Technical change to SAI M8 Line Distribution Boxes

- PCN-number: PCN-PB44-20211208-00-A
- date of publishing: 8th December 2021
- duration of validity: until further notice
- revision number: 00

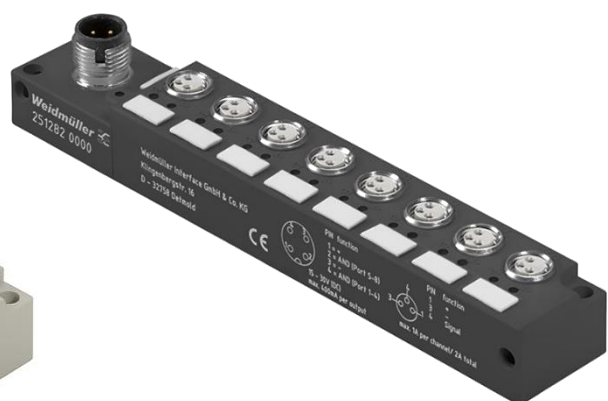
- SAI M8 Line distribution boxes have a grey housing made of Pocan plastic.
- The contact carrier was made of the black plastic Pocan.
- The inner potting on the underside was previously black and designed as mirror potting.
- The latching lugs of the marking markers are arranged asymmetrically.

- The plastic for the housing is replaced with black Pocan.
- The plastic for the contact carriers will be changed to grey Pocan.
- The potting on the underside will be left natural in future and will no longer be mirror potting. Minor sink marks on the back of the distribution boxes are possible. These have no influence on the technical data.
- The locking lugs of the new markers are symmetrically arranged.

- Due to the current economic situation, we are forced to prioritize product availability. Accordingly, we are switching to black Poca as the housing material on the one hand, and from black potting to natural potting on the other to ensure our ability to deliver in the best possible way.
- The symmetrical marker is easier to assemble because twisting is not possible. This simplifies the assembly of the markers.
